# RGR Sweater Ltd

7th June 2014

# Building Observations

# Discrepancies between designed and as-built structures

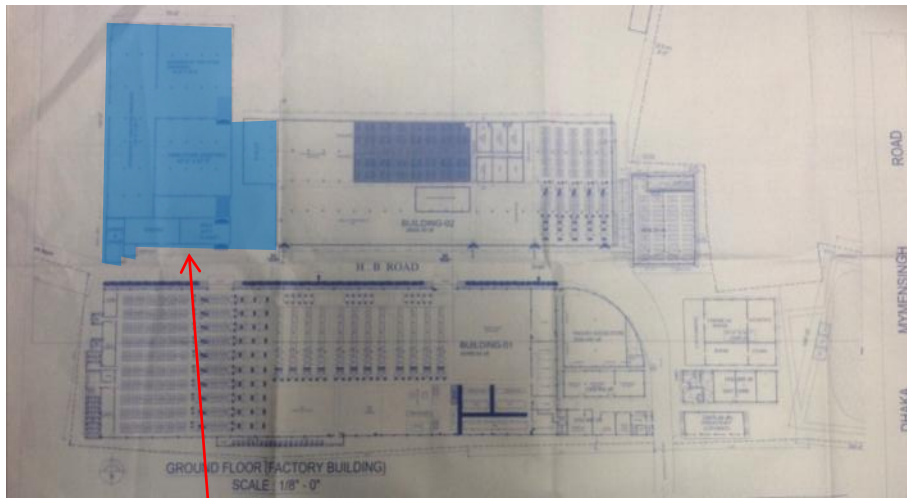
Part of the building not incorporated into the design (winding section)

| Item No. | Observation                                                 | Recommended Action Plan                                                                                                              | Recommended Timeline |
|----------|-------------------------------------------------------------|--------------------------------------------------------------------------------------------------------------------------------------|----------------------|
| 6        | Discrepancies between designed and as-built structures      | Building engineer to incorporate all additional structures to the design and to correct the as-built drawings.                       | 6-months             |
| 7        | Discrepancies between designed and as-built structures      | Prepare documentation that is missing for existing structures.                                                                       | 6-months             |

# Building 1

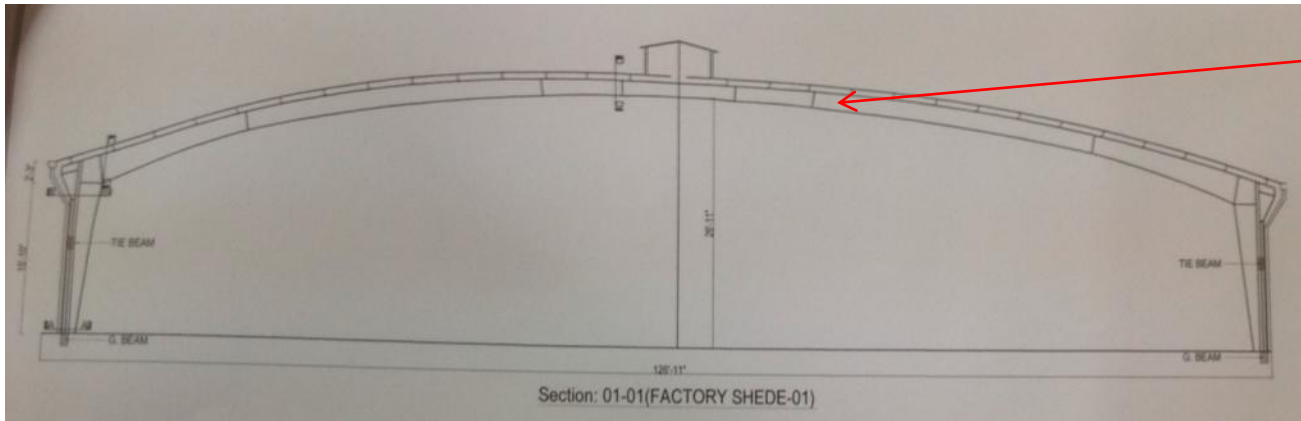
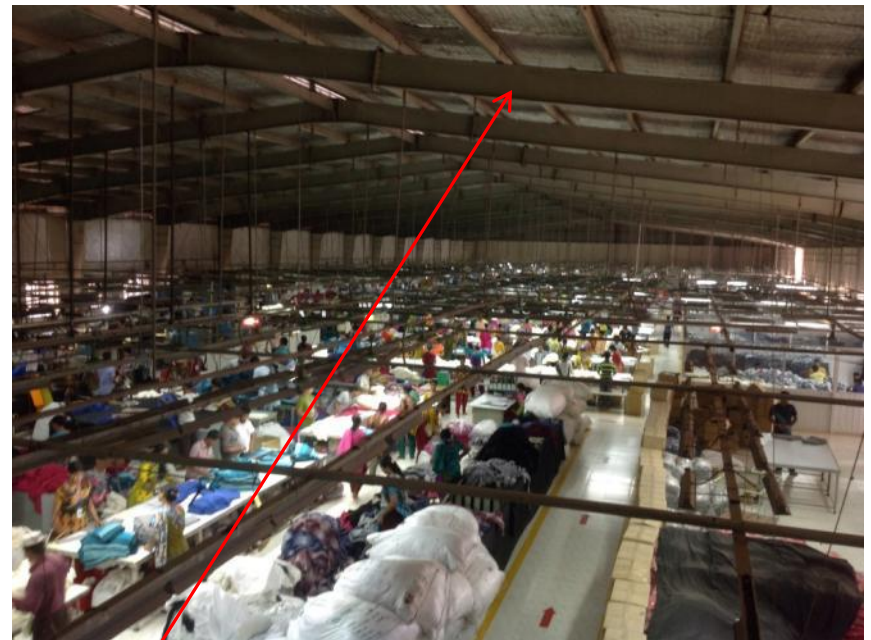
**Structure not in accordance with design**

Curved rafter structure as designed

Straight rafter structure as built

## Building 1/ Mezzanine

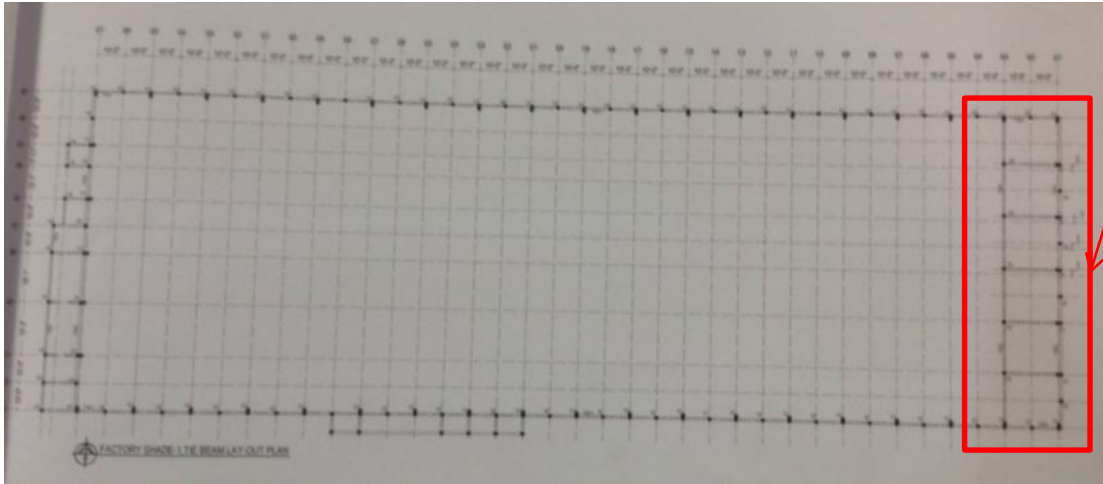
RC Beam/column simple structure as designed

RC Beam supported by steel column

Secondary Beam supported by primary beam

| Item No. | Observation                                                 | Recommended Action Plan                                                                                                              | Recommended Timeline |
|----------|-------------------------------------------------------------|--------------------------------------------------------------------------------------------------------------------------------------|----------------------|
| 1        | Unconventional support structure for the RC mezzanine beams | Building engineer to check the as-built structure with reference to proper stability and sufficient strength of structural elements. | 6-months             |
| 2        | Unconventional support structure for the RC mezzanine beams | Incorporate as-built structure into documentation and drawings.                                                                      | 6-months             |

# Untrimmed stair opening

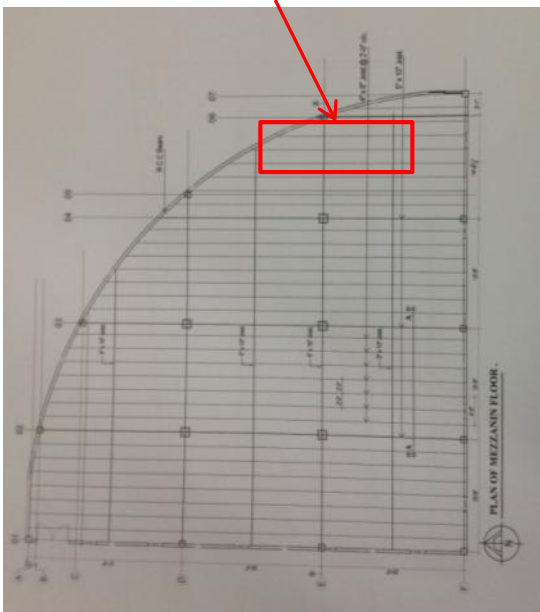
Steel beams terminated at the edge of stair opening floor 1. Works as cantilever

Additional steel stairs, location

| Item No. | Observation                                                 | Recommended Action Plan                                                                                                              | Recommended Timeline |
|----------|-------------------------------------------------------------|--------------------------------------------------------------------------------------------------------------------------------------|----------------------|
| 3        | Untrimmed stair opening in Finished Goods store             | Building engineer to check if introduced changes to design are affecting existing structure.                                         | 6-months             |
| 4        | Untrimmed stair opening in Finished Goods store             | Extend terminated beams so that they will be supported from both sides.                                                              | 6-months             |

# Localised areas of high loading

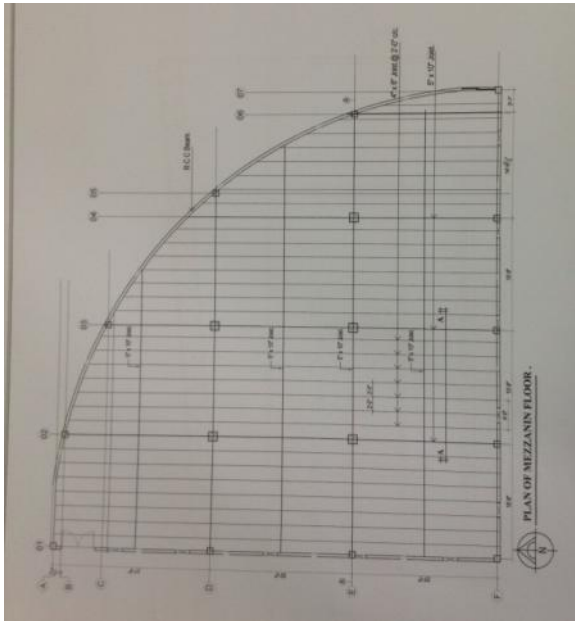
Localised areas of heavily loaded storage over whole floor. Steel sheeting supported by steel beams system structure as a floor.

| Item No. | Observation                          | Recommended Action Plan                                                                                                                                                                                         | Recommended Timeline |
|----------|--------------------------------------|-----------------------------------------------------------------------------------------------------------------------------------------------------------------------------------------------------------------|----------------------|
| 9        | Localised areas of high loading      | Building engineer to ensure the structure is not loaded beyond capacity. Produce and actively manage a loading plan for all floor plates within the factory, giving consideration to floor and column capacity. | 6-months             |

# Non-engineered steel roof structures

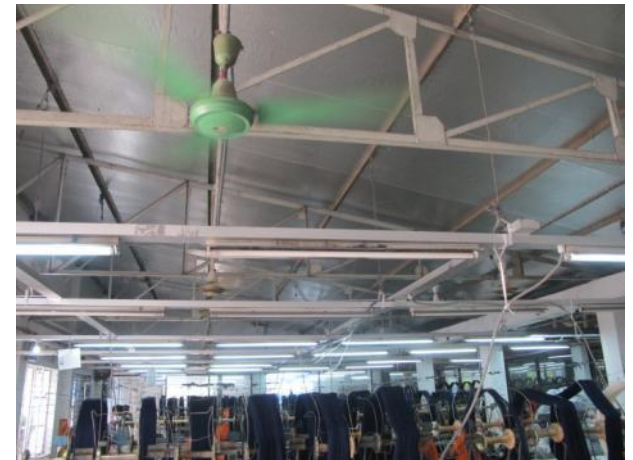
Yarn storage roof structure, some trusses supported off racking system

Chemical/waste storage roof structure; bamboo prop where truss missing

| Item No. | Observation                          | Recommended Action Plan                                                                                                                                                                                         | Recommended Timeline |
|----------|--------------------------------------|-----------------------------------------------------------------------------------------------------------------------------------------------------------------------------------------------------------------|----------------------|
| 8        | Non-engineered steel roof structures | Building engineer to check the roof structure and connections, and propose additional reinforcements and stability system to ensure the proper functioning of the structure.                                    | 6-months             |
